# **Broad Run Farms Civic Association Meeting Review of Remedial Investigation Hidden Lane Landfill**

**Mark Widdowson, Ph.D., P.E.**

**June 21, 2016**

Figures 1-3 and 1-4 (RI)

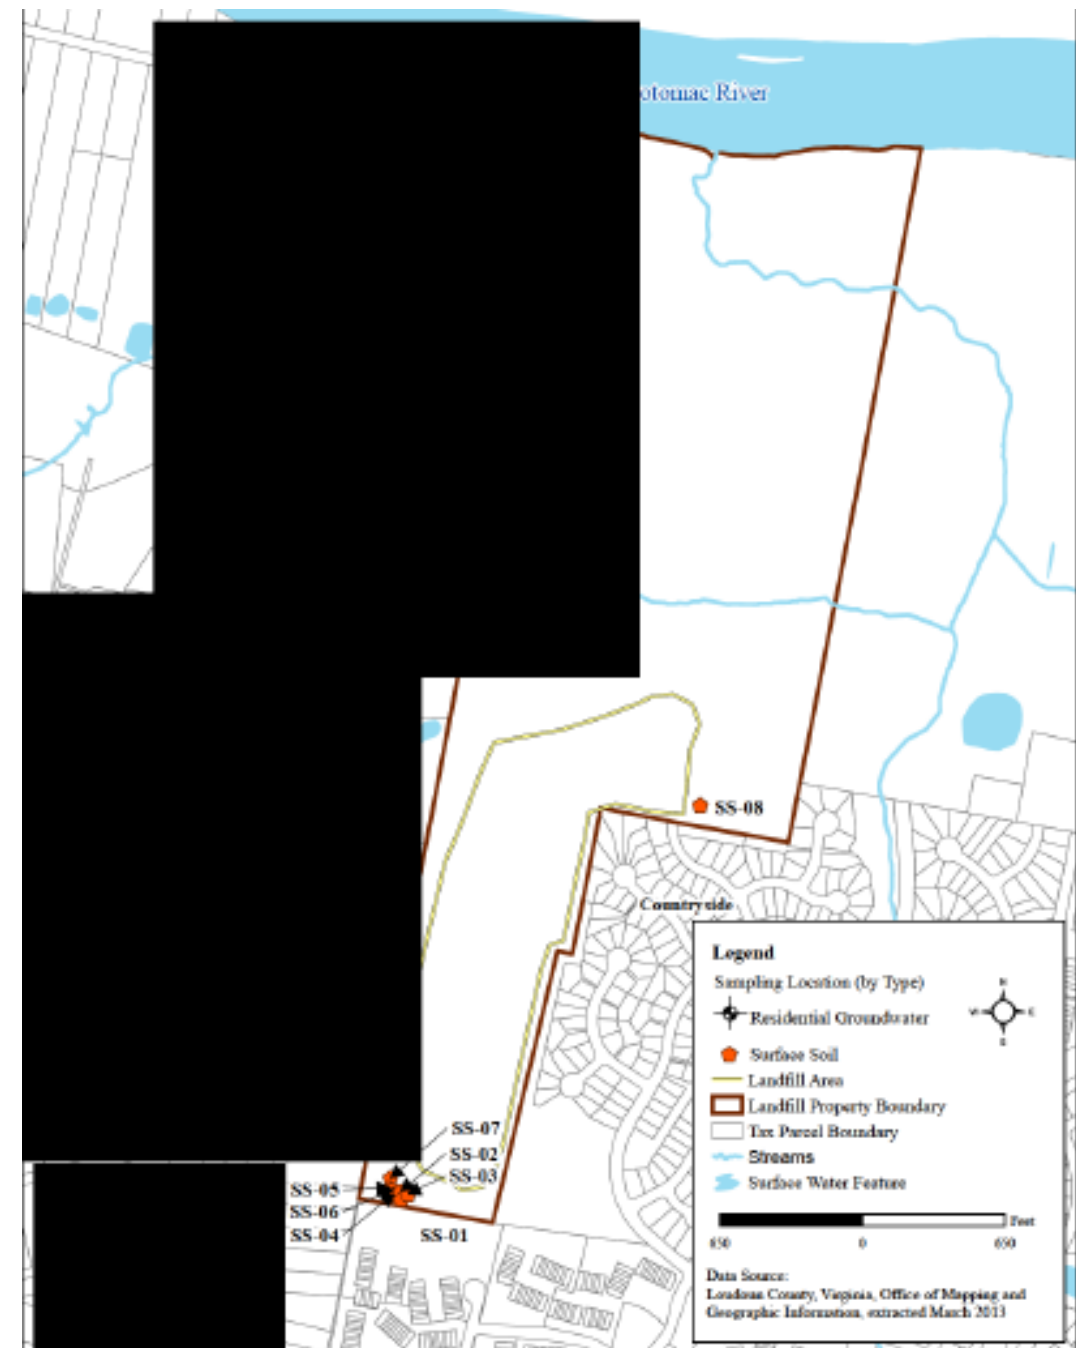
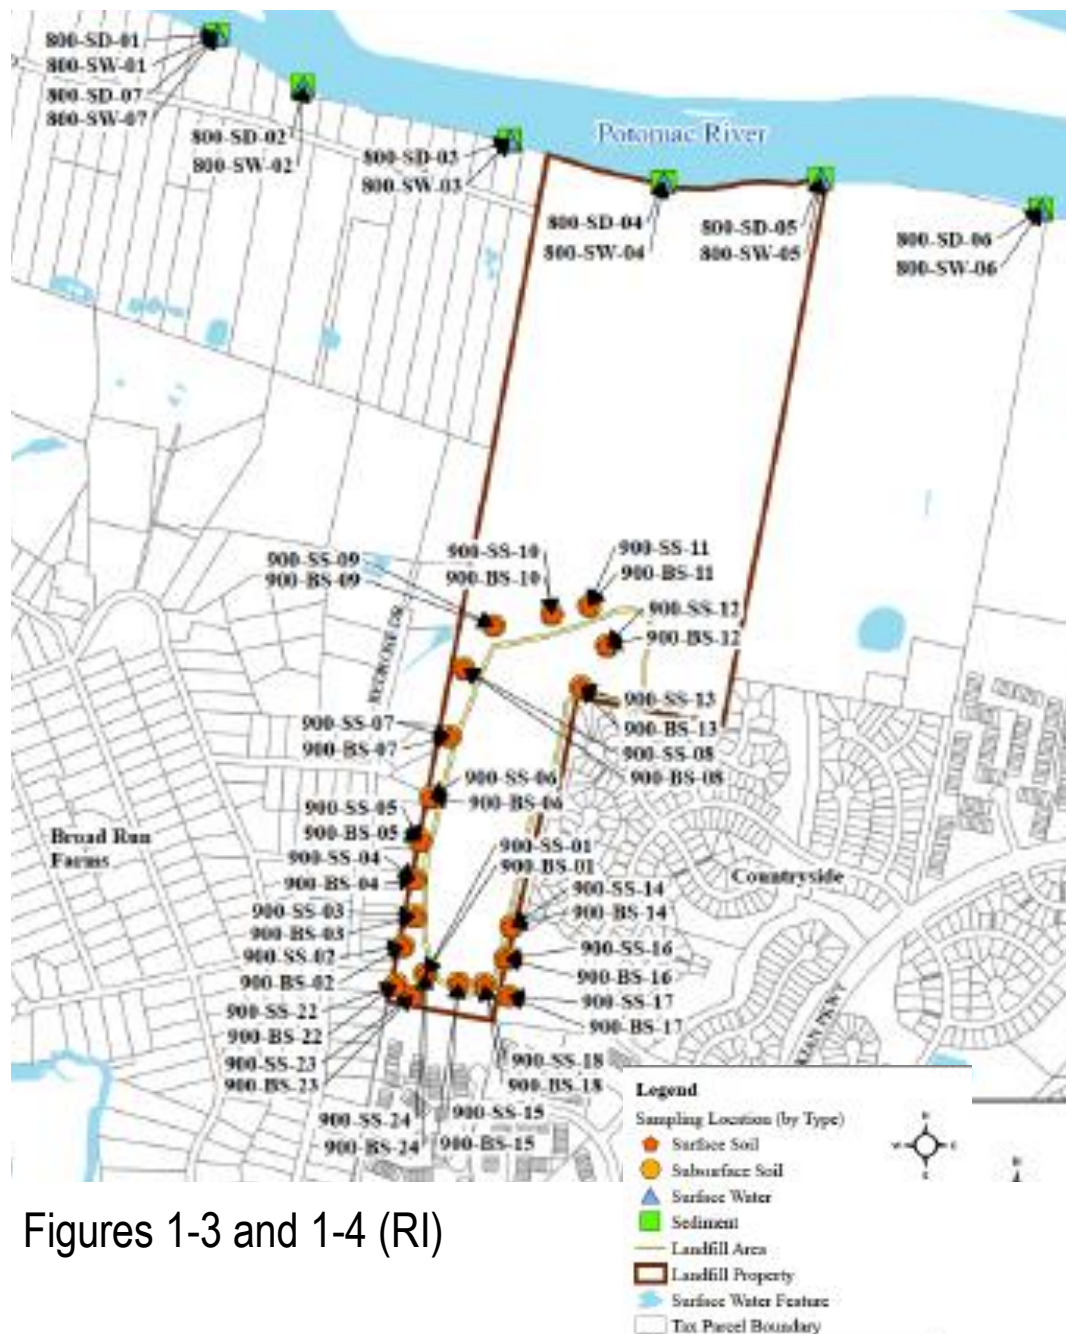
- ▶ TCE in groundwater above MCLs
- ▶ Methane in soil gas
- ▶ Metals above RSLs
  - Groundwater
  - Soil

Figure 2-2 (RI)

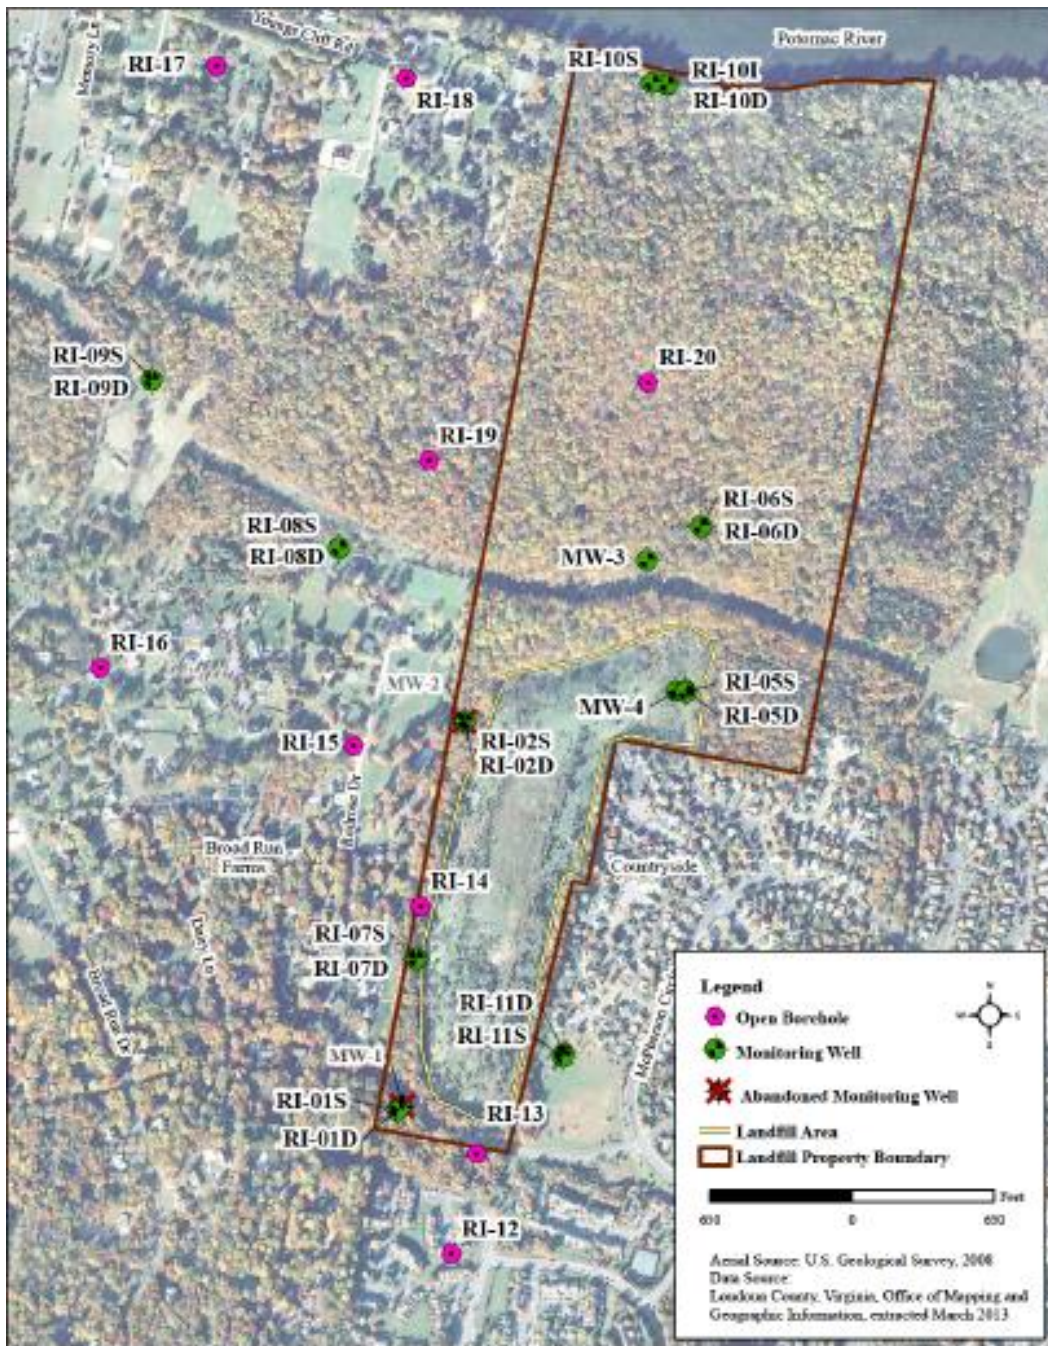
- 9 wells – 150 ft depth
- 2 screens per well (S/D)

- 9 borehole wells – 300 ft depth
- Sampled at multiple depths

- Extended 3 borehole wells to 500 ft

# Treated Tap Water (2008-2014)

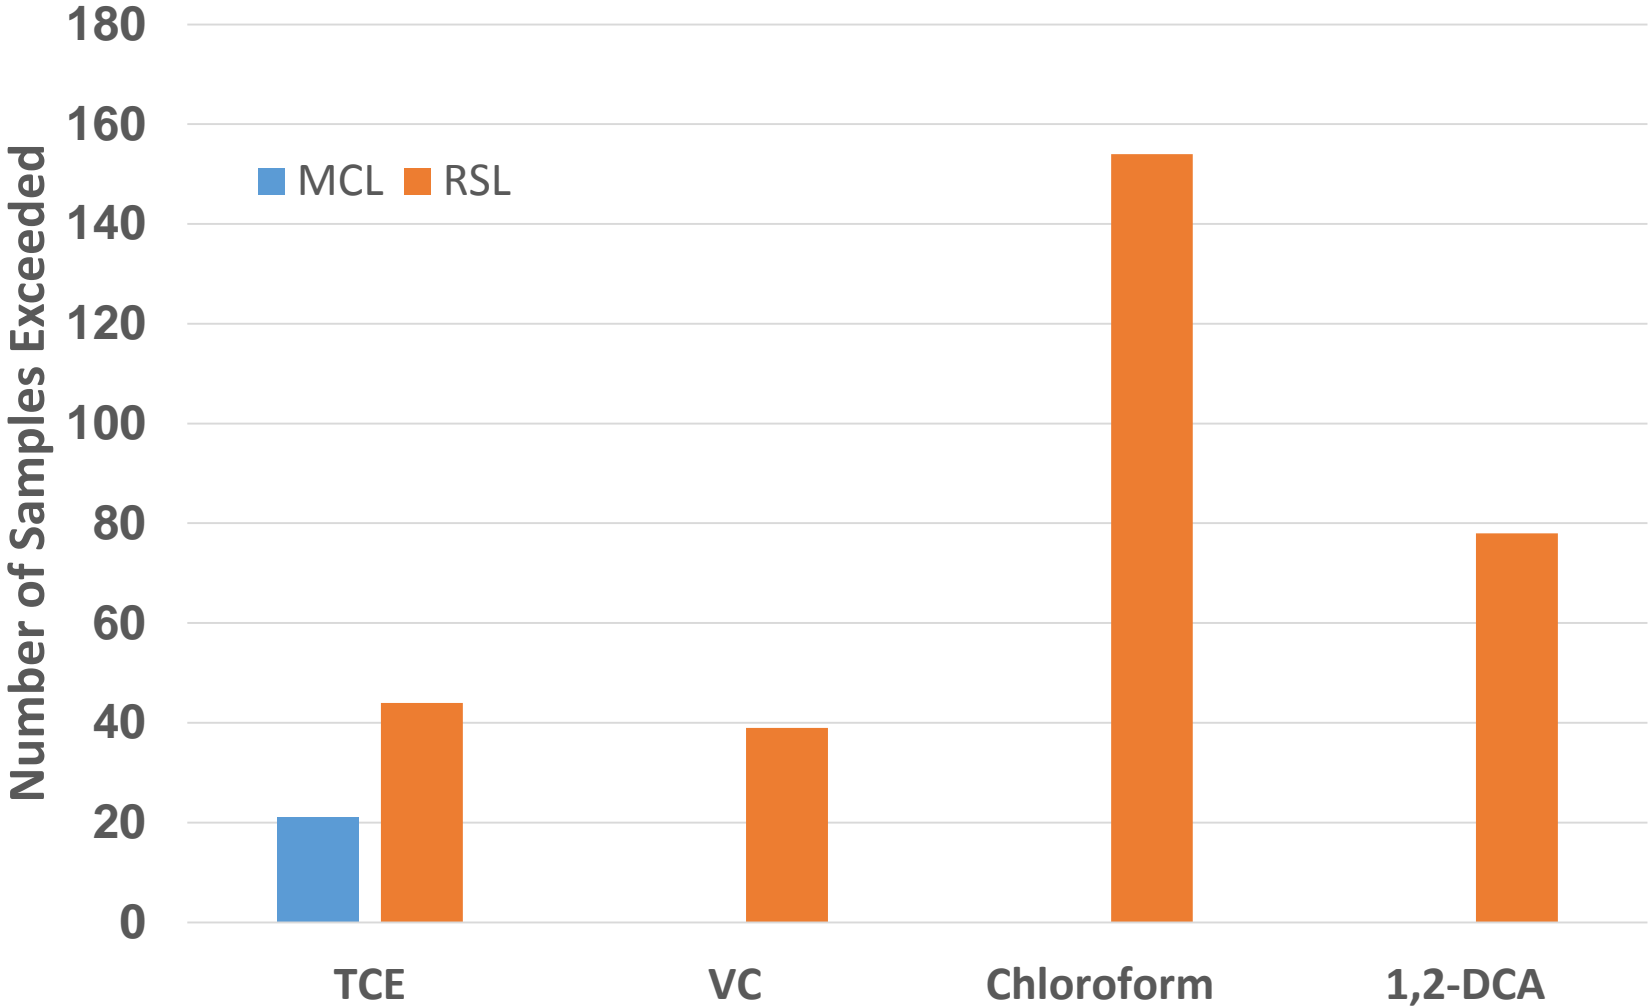
- ▶ TCE and other COPC in Treated Tap Water
  - Failures in the treatment systems to eliminate TCE below MCL
  - Responsiveness of contractor to TCE > MCL – Maintenance, Communication
  - Other VOCs and Metals above RSLs
- ▶ Metals – Direct the contractor to immediately begin consistent monitoring of wells and tap water for metals
- ▶ Redaction – Release the ID system for residential sampling locations
